LINCOLN CITY/LANCASTER COUNTY PLANNING STAFF REPORT

for August 2, 2006 PLANNING COMMISSION MEETING

PROJECT #: Preliminary Plat #06009 - Grandale
Special Permit #06044 - Grandale Community Unit Plan

PROPOSAL: Preliminary Plat #06009 - A preliminary plat of 189 lots.
Special Permit #06044 - To allow a community unit plan for approximately 34 single-family dwelling units.

GRANDON PRELIM. PLAT

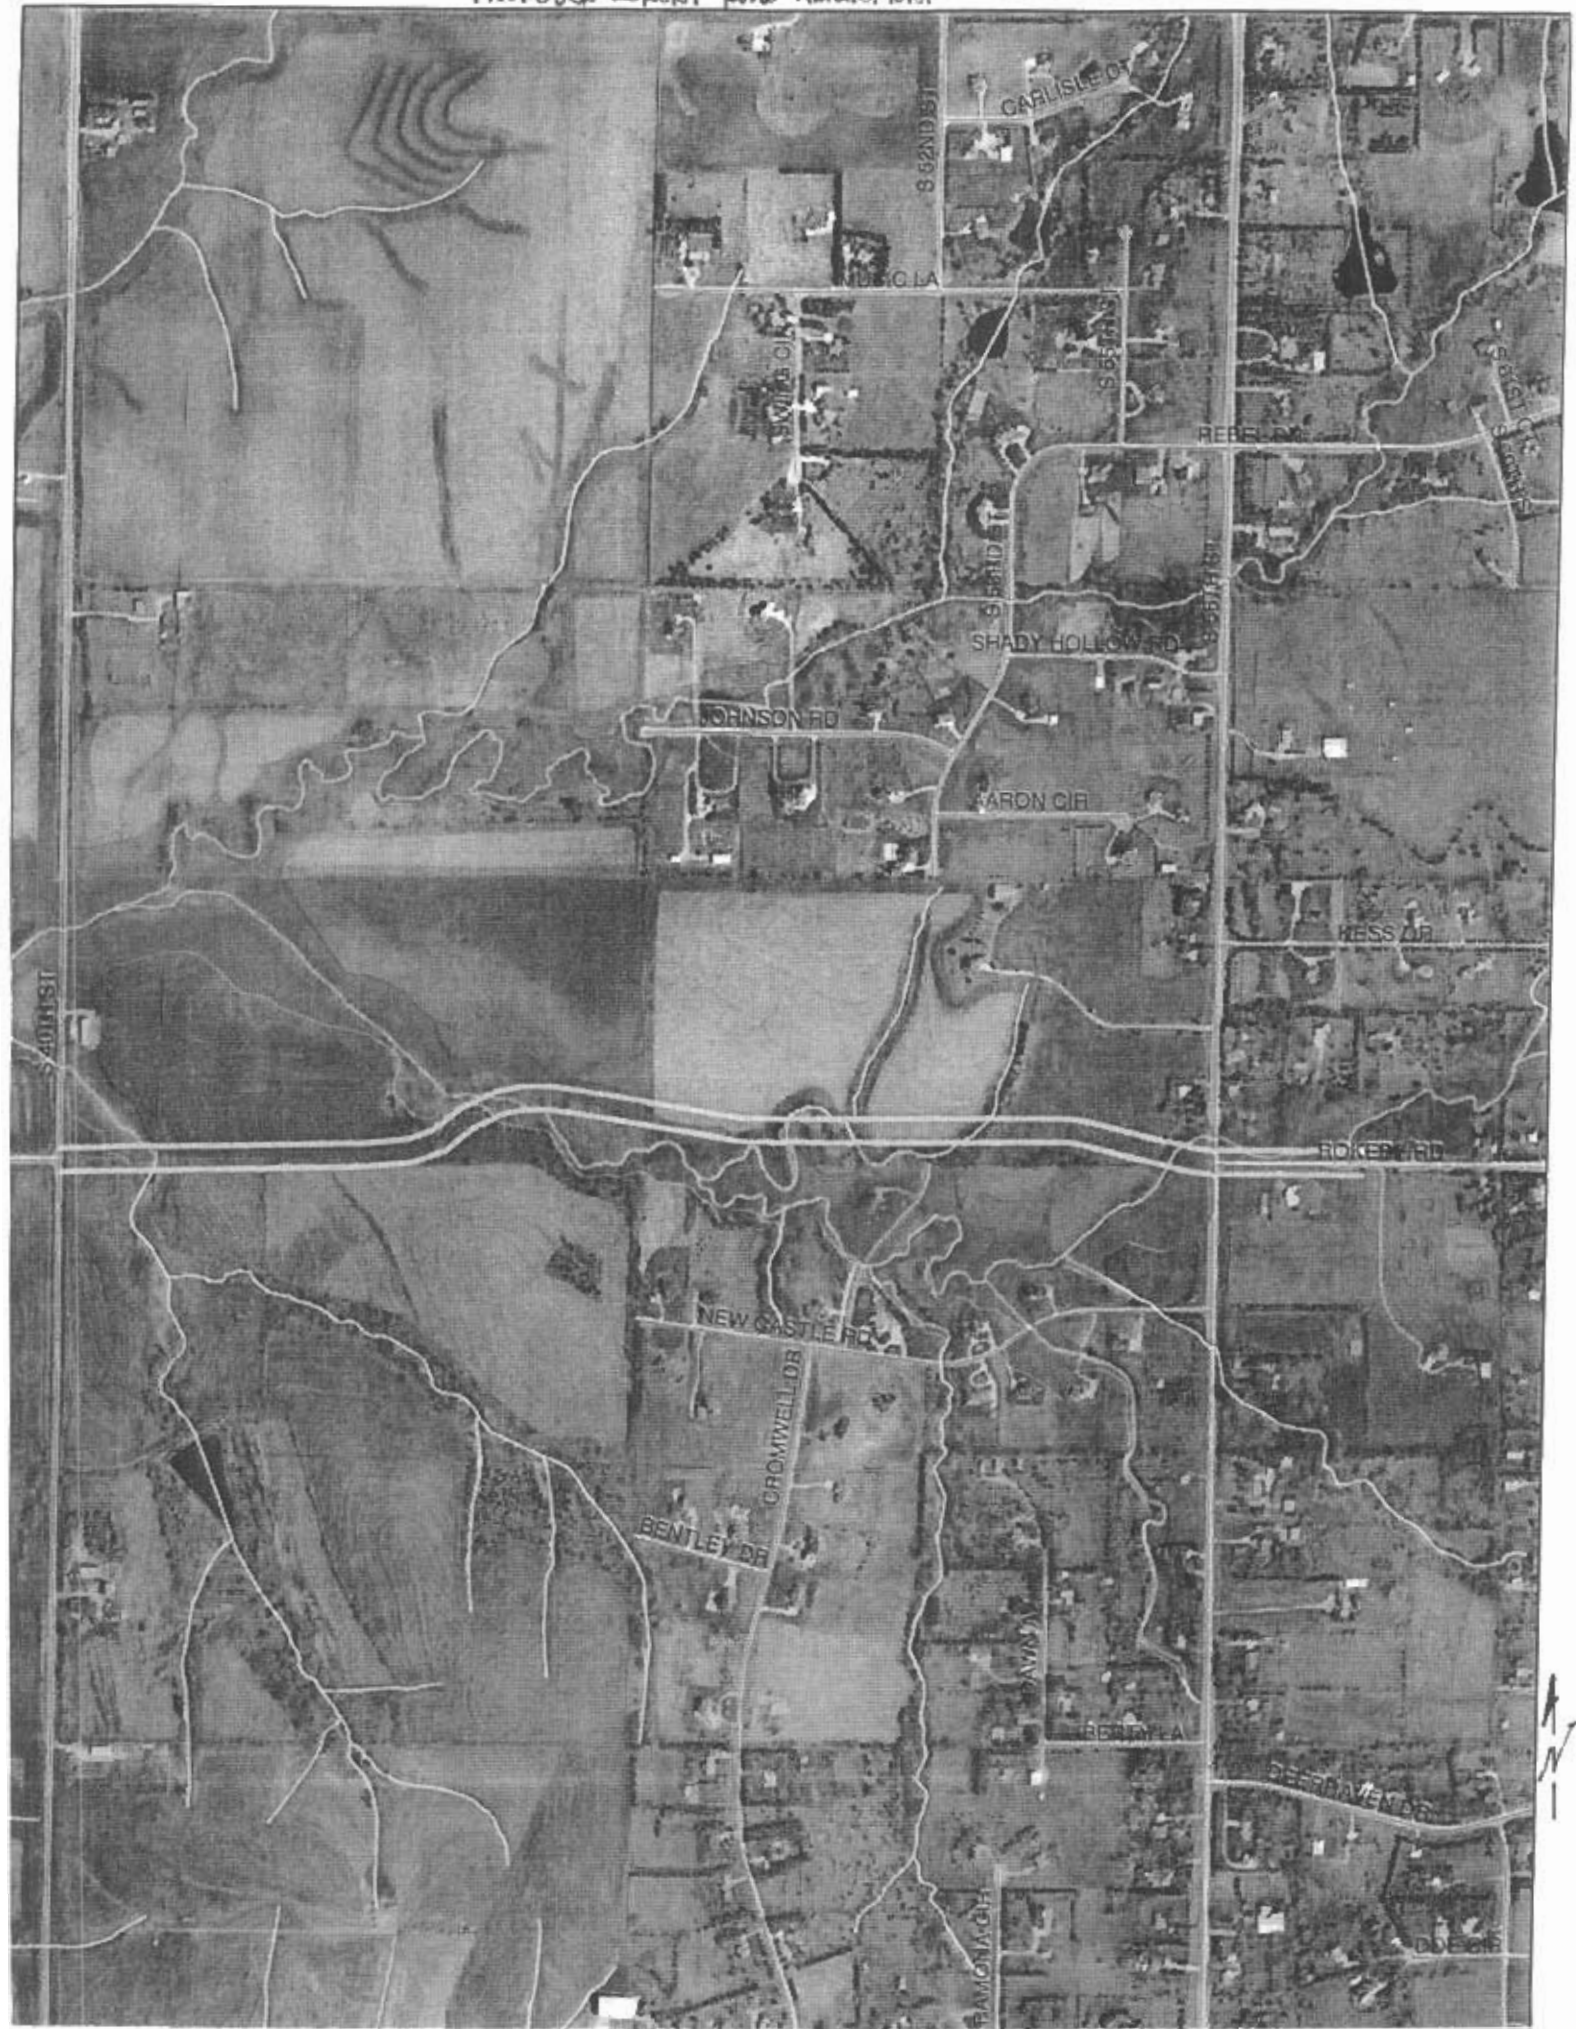
1. Block length in excess of 1,320' - The justification provided by the applicant is to minimize stream crossings. Reducing the block length requires a street connection between the area of the CUP and Golden Rod Drive to the south. Public Works has stated that the conservation easement does not prohibit crossing the drainageways, and in the absence of other justification the connection should be provided.

3. Connection to adjacent street system. The justification provided to not connect to Johnson Road at the northeast corner of the plat is to avoid a costly channel crossing, and to reduce the amount of traffic entering the development to the east. Staff recommends denial of this waiver because the justification does not provide evidence that the connection is not feasible. Additionally, the Comprehensive Plan encourages such connections to support the overall theme of "One Community" and to provide connectivity among neighborhoods. Connectivity between neighborhoods reduces the traffic demand on the surrounding arterial streets. Such connections result in a more efficient transportation system with multiple routes in and out of neighborhoods, thereby reducing the traffic demand on individual local streets. While the connection may result in increased traffic through the adjacent Kensington Estates acreage development, it will also provide acreage owners better access to the future commercial centers along South 40th Street and Yankee Hill Road

4. Non-standard intersection. Public Works denies this request.
5. Less than minimum centerline curve radius. Public Works notes it violates safety requirements and denies this request.
6. Exceed maximum intersection approach grades. Public Works finds the grade excessive and denies this request.

6. The design of Rokeby Road also requires intersections and median openings to be determined at this time for that portion adjacent to this plat. Public Works notes that the South 43rd Street intersection must be moved east to provide a 1/4 mile separation from South 40th Street. This requires the lot layout to be revised to extend Coral Bell Drive to Rokeby Road, and elimination of the South 43rd Street/Rokeby Road intersection.

7. A waiver to allow a block length in excess of 1,320' is requested. The justification is "to minimize the number of stream crossings." Public Works notes that the conservation easement the City purchased does not prohibit stream crossings, and the waiver should be denied. The most suitable location for a connection would be between from Golden Rod Drive and the private roadway in the CUP on Outlot K. This connection provides access to the median opening at Willow Road and the future employment center west of South 40th Street, and would also allow access to the Southwood Lutheran Church on Lot, Block 1 without having to use the adjacent arterial streets.

of the plat. It was platted and built with the intent that it would connect to a future street when the adjacent property was developed. In the absence of adequate justification, staff recommends the street connection be made as originally intended consistent with the Comprehensive Plan and Land Subdivision Ordinance.

12. 911 Emergency Communications notes several required corrections to the proposed street names. They must be revised to the satisfaction of 911 and the Planning Department.

13. The Fire Department has denied the proposed hydrant layout due excessive spacing. The hydrant plan must be revised and approved by the Fire Department.

(4.1) The proposed horizontal alignment for Rokeby Road is not satisfactory. The proposed alignment shows two sets of reverse curves. Reverse curves are acceptable where the curve radiuses are sufficiently large as to not require superelevation. The proposed radiuses would not only require superelevation, they also would require a superelevation rate greater than the maximum rate used by City standards and recommended by national guidelines for urban streets. The Rokeby Road alignment needs to be revised to meet arterial street standards with a required 50 mph design speed.

(4.3) The required 120' wide ROW needs to be shown for Rokeby Road. At the intersection locations 130' wide ROW needs to be shown to provide for the required turn lanes.

(4.4) The proposed profile for Rokeby Road appears to be designed based on a 45 mph design speed. Arterial streets are to be designed based on a 50 mph design speed. The Rokeby Road profile and associated grading need to be revised using a 50 mph design speed.

(4.7) Public Works does not approve the generic block length waiver. Specific waiver locations should be identified and justified. Public Works specifically objects to the block length waiver between 46th and 40th Streets. The proposed plat shows a pedestrian crossing approximately at the location of Curve Q in Golden Rod Drive. This crossing is shown to require a twin 12' x 8' box culvert. Public Works would approve a street section waiver to construct a narrower street with no parking in this location. The street would provide connectivity between the two residential areas.

(4.11) It appears possible to make a connection to the existing Johnson Road from the acreage development in the northeast part of the plat. The connection would require a large multi-barrel box culvert to meet flood regulations. Also, it is likely that easements would be required on the existing acreages to the east if the culvert structure increased flood elevations on those properties. The developer could also apply to the Corps of Engineers to re-align the channel if such a change would better facilitate the crossing.

- 1.1 Revise the preliminary plat to show:
 - 1.1.1 A street connection to existing Johnson Road unless the subdivider's waiver request is approved by the City Council.

- 1.1.2 No block length in excess of 1,320' unless the subdivider's waiver request is approved by the City Council.
 - 1.1.3 All intersections meeting Design Standards.

- 1.1.4 All centerline curve radii meeting Design Standards.
 - 1.1.5 All intersection approach grades meeting Design Standards.
 - 1.1.6 120'/130' of right-of-way dedicated for Rokeby Road.

- 1.1.7 Rokeby Road aligned to the satisfaction of Public Works and Utilities.
 - 1.1.8 Street intersections along Rokeby Road located approximately one-quarter mile apart to the satisfaction of Public Works and Utilities.

- 1.1.9 An easement to accommodate the bike trail in a location and of adequate width to the satisfaction of the Parks and Recreation Department.
 - 1.1.10 Add a general site note that states "LOTS 16-18, BLOCK 10 AND LOTS 8-14, BLOCK 16 SHALL NOT BE FINAL PLATTED UNTIL SUCH TIME AS THEY HAVE FRONTAGE TO A DEDICATED PUBLIC STREET."

1.1.13 A revised fire hydrant layout approved by the Fire Department.

1.1.17 General Site Note #18 revised by deleting “ACCEPT AS ADJUSTED AND SHOWN BY THIS PERMIT.”

1.1.18 General Site Note #21 revised to state “.....IF THEY HAVE ACCESS TO A PUBLIC ACCESS EASEMENT.”

1.1.19 General Site Note #22 deleted.
